## MORRIS·MINI·MOKE

### **1<sup>st</sup> Edition Corrections**

**Last update 2/9/2022**

Fig. 5.1.9 Fuel supply pipes AYK2085.

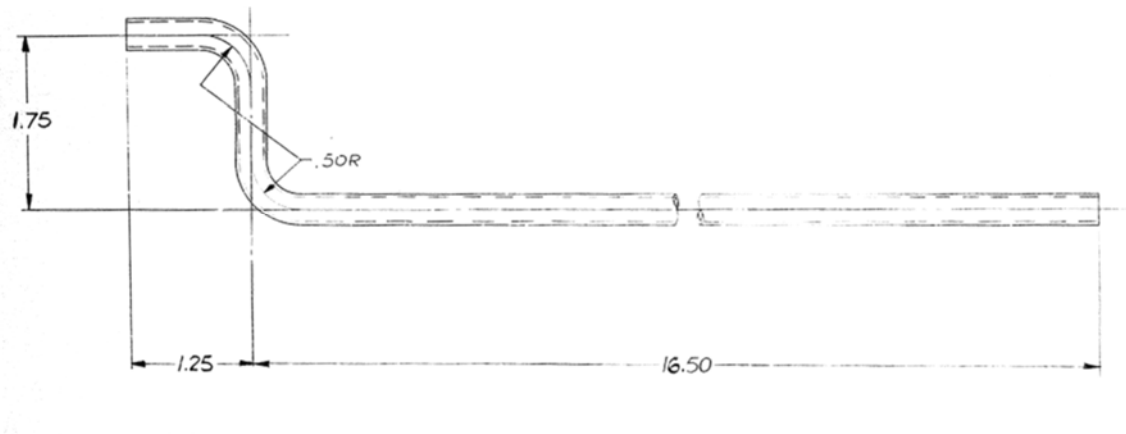
Page 86. Fuel supply lines shown for saloon in error. Revised pictures below.

Coated steel Bundy tube ¼" AYK2085 OD supplies fuel from the tank to flexible hose AYA2055 11.5" long, and then AYK2086 flexible hose to pump.
